SALEM NUCLEAR GENERATING STATION, UNIT NO. 1

AMENDMENT TO FACILITY OPERATING LICENSE

Amendment No. 28  
License No. DPR-70

ATTACHMENT TO LICENSE AMENDMENT NO. 28

FIGURE 6.2.2 FACILITY ORGANIZATION - SALEM GENERATING STATION

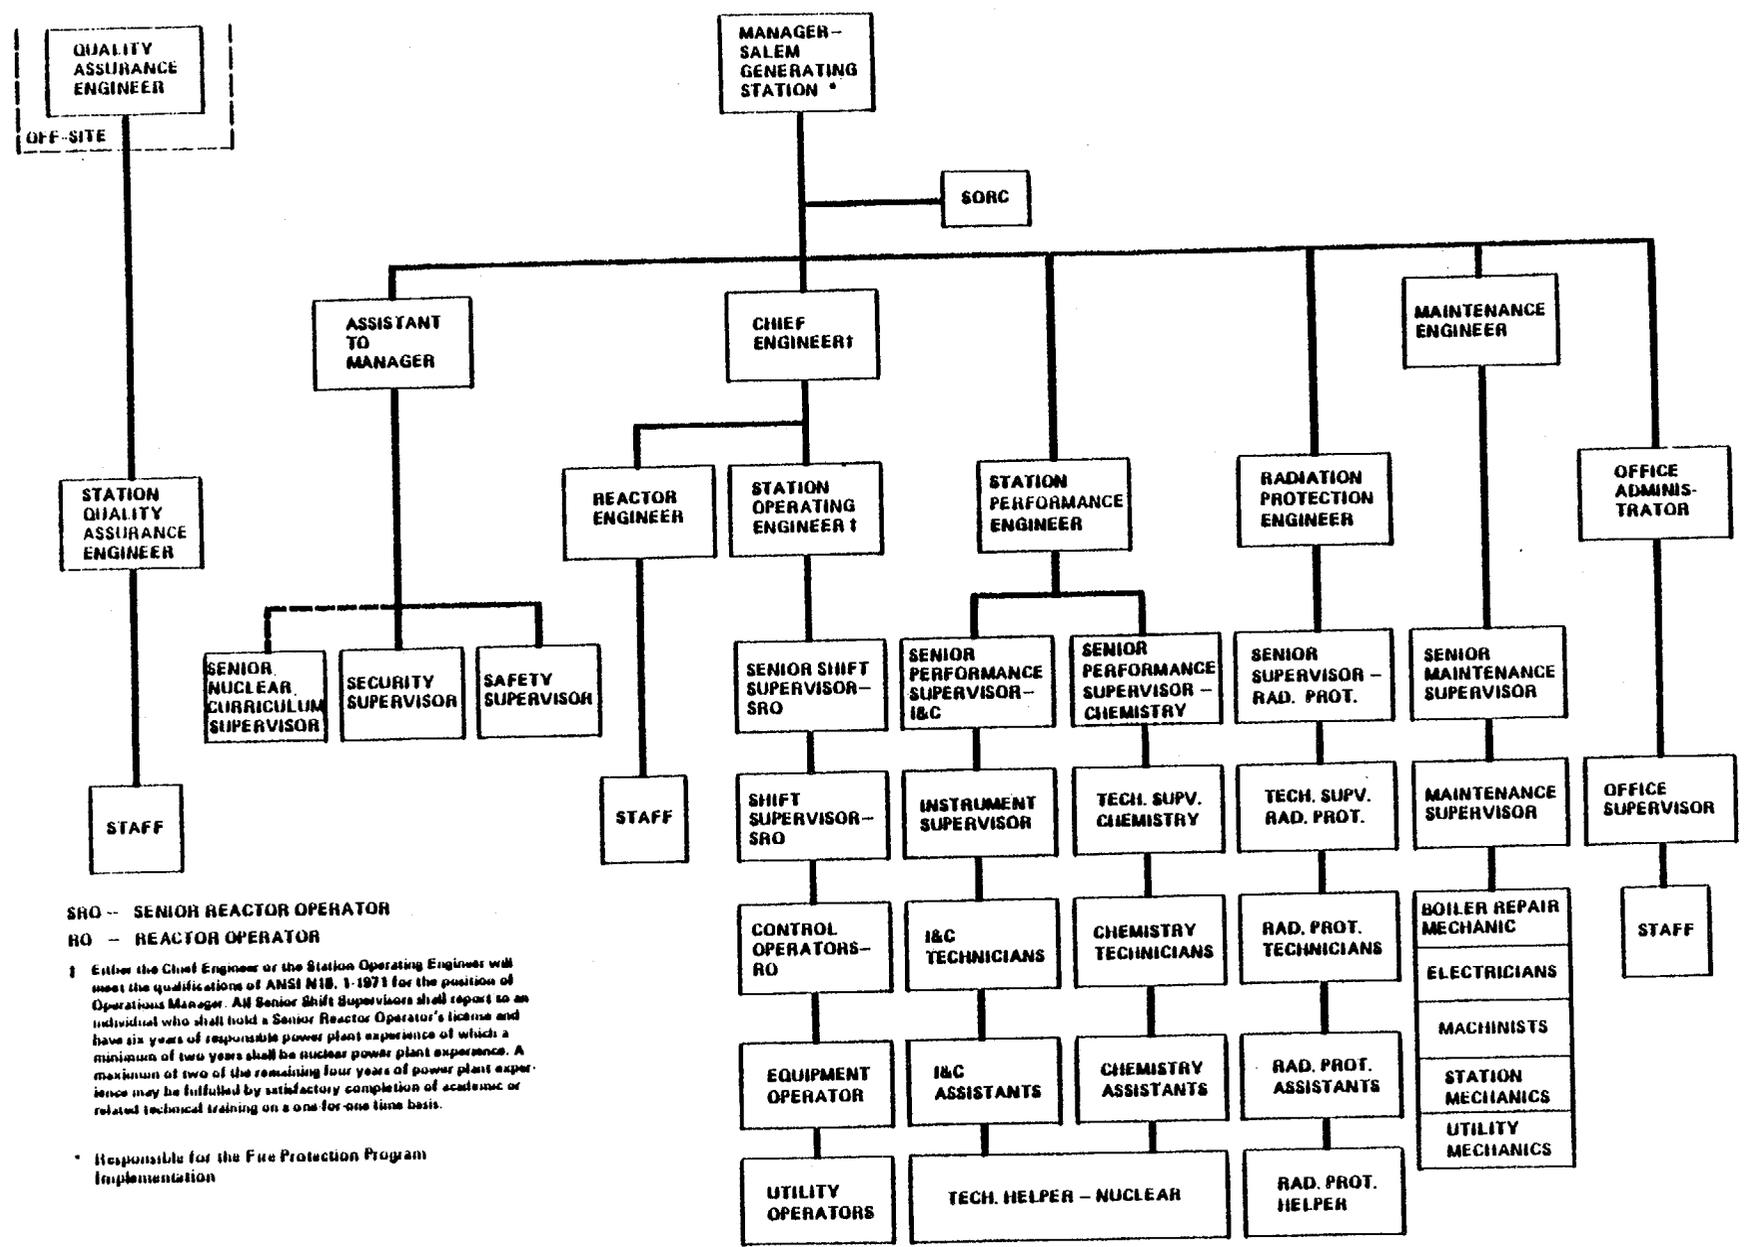
By letter of August 22, 1980 the licensee proposed changes to the Salem Radiation Protection organization that provide for the separation of the radiation protection function from the Performance Department and formation of a new Radiation Protection Department. This new department will be headed by a Radiation Protection Engineer who will report directly to the station manager. It will have a Senior Supervisor - Radiation Protection (who will act as backup to the Radiation Protection Engineer), Technical Supervisors, Technicians and Technical Assistants, all of whom will be devoted to the function of radiation protection. The remainder of the Performance Department will be modified to split the Technical Assistants such that they are devoted to either the instrumentation and controls function or the chemistry function.

1. The Radiation Protection Engineer (RPE - equivalent to the Radiation Protection Manager) reports directly to the Station Manager, independent of operational, technical or administrative groups. The RPE is a required member of the Station Operations Review Committee (SORC). Staff qualifications require that the RPE meet or exceed the recommendations of Regulatory Guide 1.8.

2. The newly formed Radiation Protection Department has an independent radiation protection function at all levels, and is separate from such functions as chemistry. A backup to the RPE, the Senior Supervisor-Radiation Protection has been designated. All Technical Supervisors, Technicians and Technical Assistants within the department are devoted to the radiation protection function.
